June 6, 2007

TO: Councilor Robert Liberty, Metro
FROM: Doug Ficco, John Osborn, and Kris Strickler
COPIES: Richard Brandman, Metro
SUBJECT: Questions Pertaining to the Columbia River Crossing Project

Southbound I-5 Vehicle-Trip Patterns in the Bridge Influence Area, for Trips Across the Interstate Bridge (205)

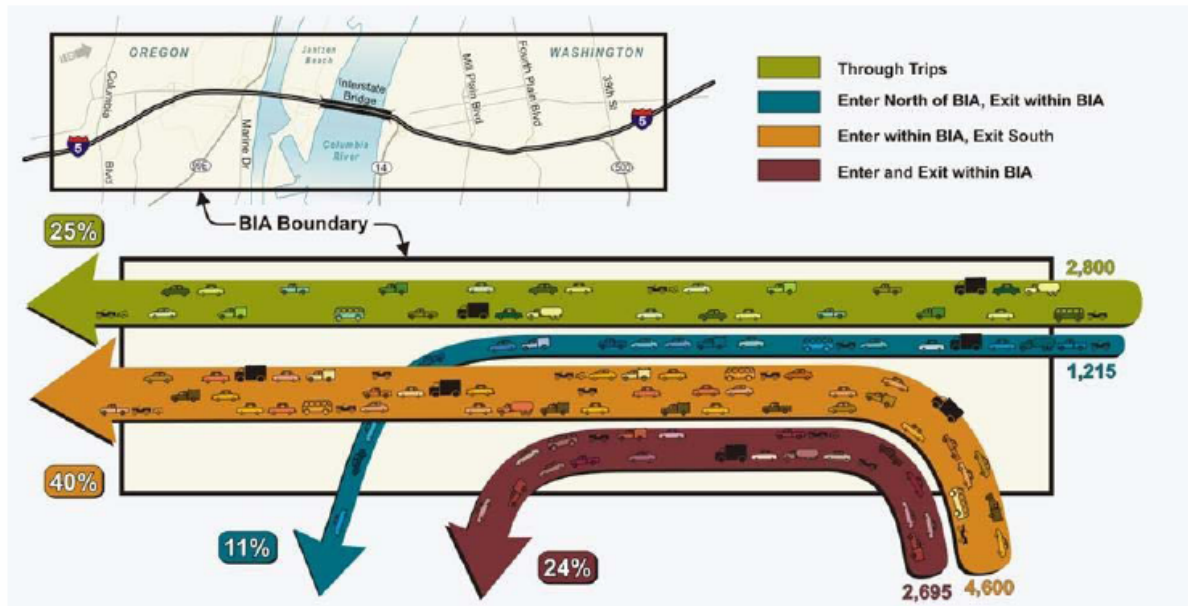
1. What percentage of southbound AM peak trips have destinations in the city of Portland?

- 25% of southbound traffic using the bridge goes all the way through the five-mile range;
- 11% enters north of the BIA and exits at one of the ramps within the BIA south of the river;
- about 40% enters the freeway in the Vancouver portion of the BIA; and
- about 24% enters the BIA in Vancouver and then exits the freeway at the Hayden Island, Marine Drive, or Victory exit ramps.

These data are based on our most recent analysis of travel patterns was conducted in the fall of 2005, when we recorded license plates of all vehicles getting on or off the freeway in the BIA (see figure below).

Northbound I-5 Vehicle-Trip Patterns in the Bridge Influence Area, for Trips Across the Interstate Bridge (2005)

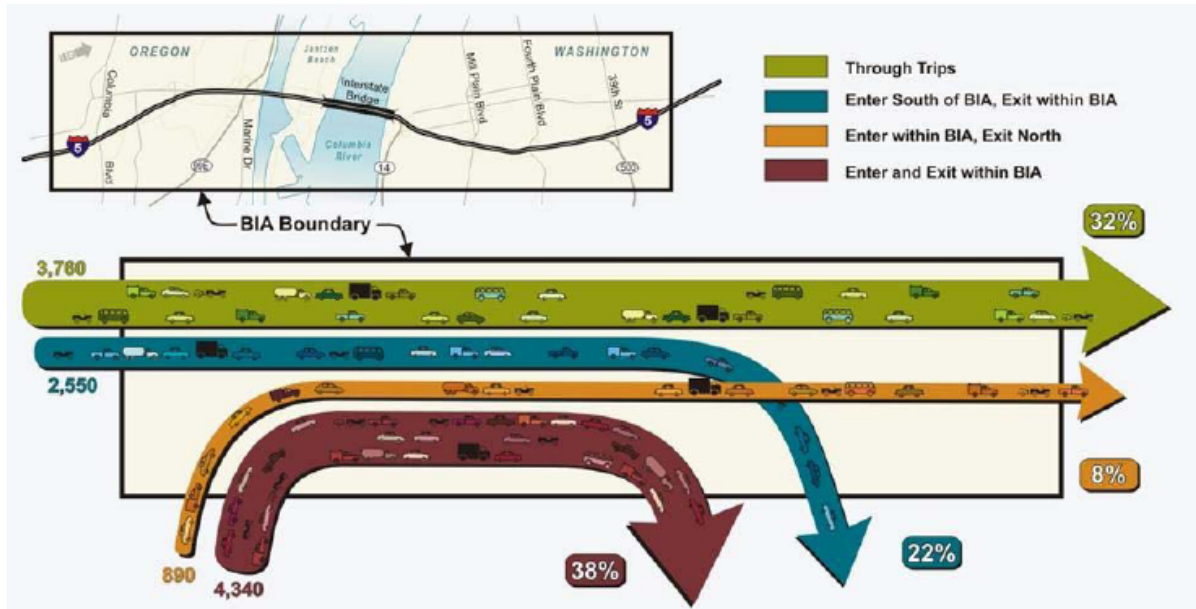
3. What percentage of northbound PM peak trips have destinations outside the city of Vancouver?

From the license plate study noted above, northbound PM peak period trips break out as follows:

- 32% are through trips (staying on I-5 all the way through the BIA);
- 22% enter the BIA on I-5, and after crossing the river exit in the Vancouver portion of the BIA;
- 8% enter on one of the I-5 on-ramps in the Portland portion of the BIA, and stay on I-5 to a location north of the BIA; and
- 38% enter within the BIA, cross the river, and then exit while still within the BIA.
